## Agenda Item 625-1016 (DDOME)

### Title: Addition of Double Roof Full Containment Tank (DRFCT) System

Date: Nov 13, 2023

Revision: 2

**Figure 12 – Full Containment Tank System  
Double Roof with Steel Primary Liquid Container and Concrete Secondary Liquid Container**

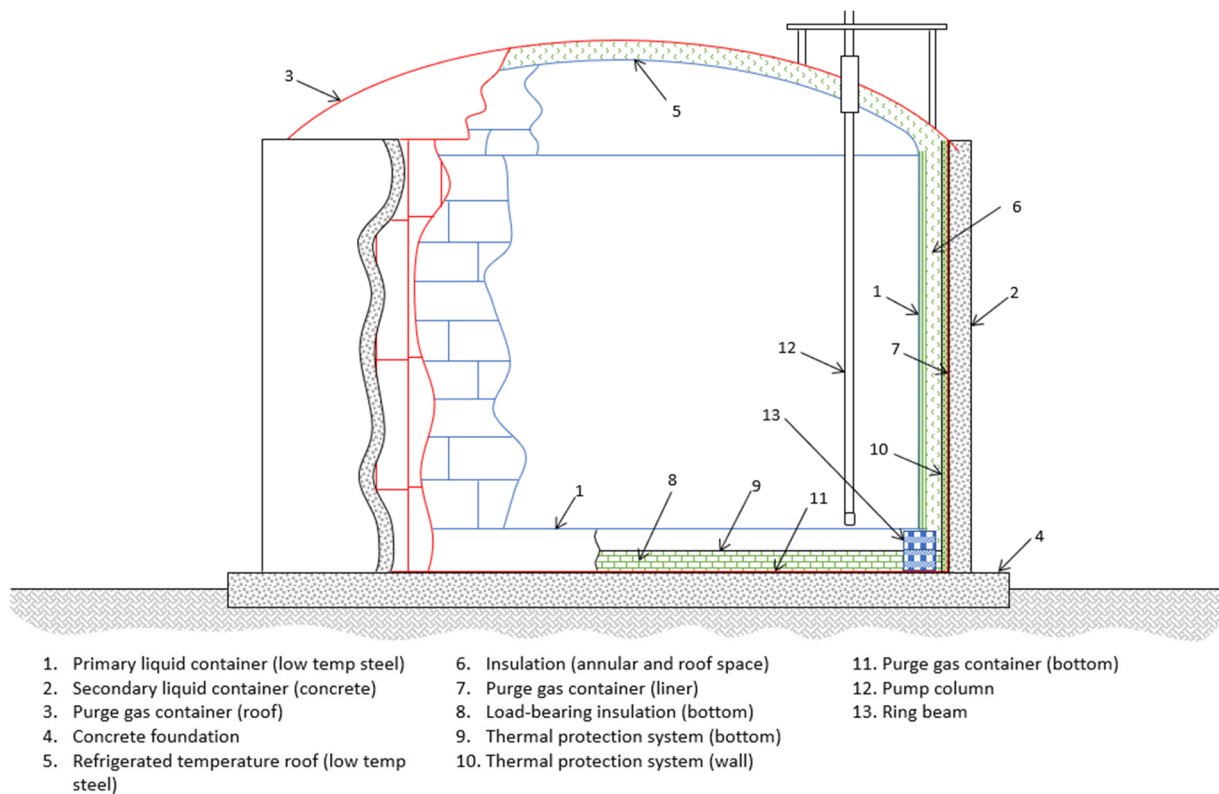
**5.4.6** Some variants of full containment concepts are depicted in Figure 8, Figure 9, Figure 10, Figure 11 and Figure 1244.

**5.4.8** In case of tanks with refrigerated temperature roof, the primary liquid container and refrigerated temperature roof shall be capable of both containing liquid and vapor product during normal service.

**Add Figure 12 below.**

Figure 16b – Liquid Levels and Volumes (tanks with refrigerated temperature roof)

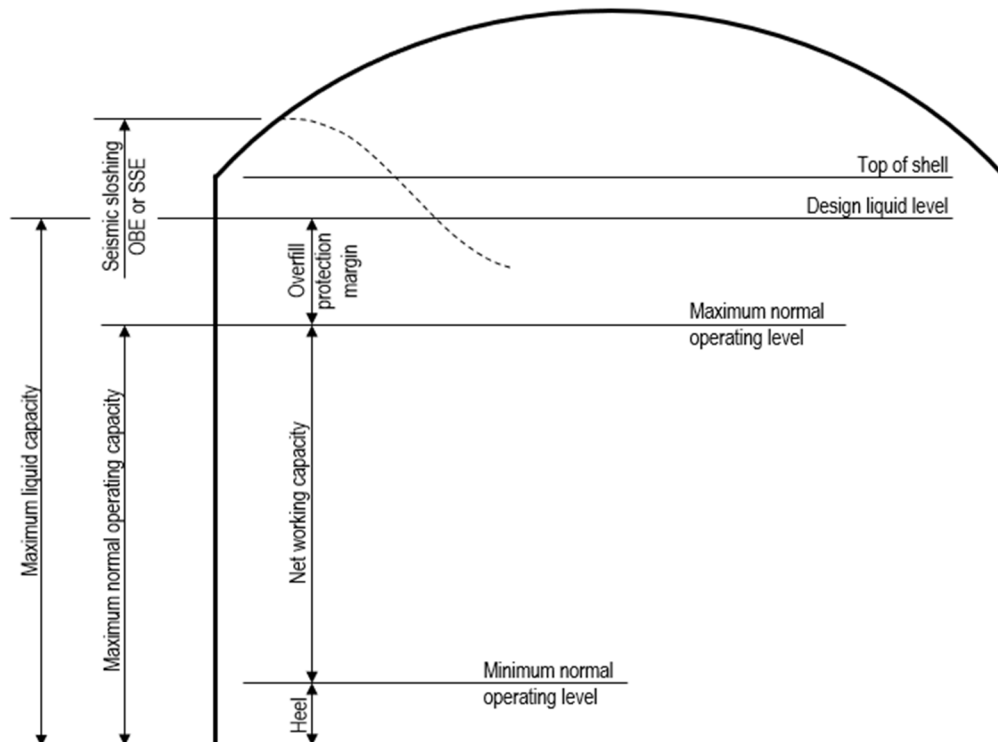
6.3.1 Figures 16a and 16b provides a graphical representation of the relationship of the terms used to define liquid levels and volumes.

Add Figure 16b.

**6.3.2.2** For tanks ~~without a suspended deck with a refrigerated temperature roof~~, consideration of a percentage of volume for vapor, design for cryogenic conditions if exposed, and dynamic behavior of the fluid under a seismic event shall be considered in the design. **The design liquid level shall not be higher than the top of shell.** ~~The height of the tank may need to be increased further to satisfy seismic freeboard requirements. Seismic freeboard shall be calculated per 6.6.9.~~
